Docket Item # 11  
BAR CASE # 2007-0210

BAR Meeting  
October 17, 2007

**ISSUE:** Alterations  
**APPLICANT:** Ian McGrath by Ray Lewis  
**LOCATION:** 1315 King St  
**ZONE:** KR/King Street Retail

The applicant is requesting approval of a Certificate of Appropriateness for alterations to the front elevation of 1315 King Street.

Figure 1: Proposed elevation

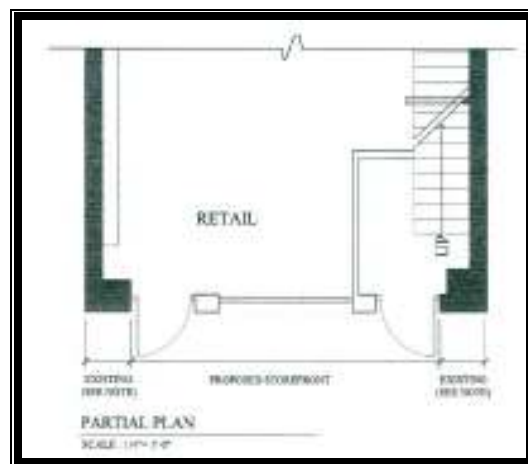
In general, Staff is very supportive of the proposed alterations to this building, which are more compatible to the building. The front elevation has had numerous alterations over the years that were unsympathetic to the character of this building, including the existing storefront, with the wood shingle overhang, and multipaned window. Past attempts at mortar and masonry repair have been careless and shoddy. In addition, the existing windows on the second and third floors are currently windows with sandwich muntins and the brick rowlocks appear to be more recent alteration.

Staff is concerned about the type of brick that could be used for any repairs at the storefront and on the upper levels and would desire to see an example before use. Staff would also like to see a sample of the honed slate base. Also, while staff commends the applicant for removing the inappropriate existing windows, staff would recommend that the replacement windows be six-over-six, double-hung, true divided light, wood windows, in keeping with the Design Guidelines, not simulated or fixed divided light. Staff would also recommend that the new transoms on the storefront level also have true divided lights rather than simulated ones.

Staff would also ask the applicant to clarify whether the building will be repainted once any mortar and masonry work is completed, as the second and third floors are currently painted.

- 1) That the new windows on the second and third floors be six-over-six, double-hung, true divided light, wood windows;
- 2) That the new transoms on the storefront have true divided lights;
- 3) That the applicant provide a sample of any brick to be used as a replacement on the elevation for staff review and approval before use;
- 4) That a sample of the honed slate base be provided to staff for review and approval; and,
- 5) That the applicant clarify if the building will be repainted following mortar and masonry repairs.
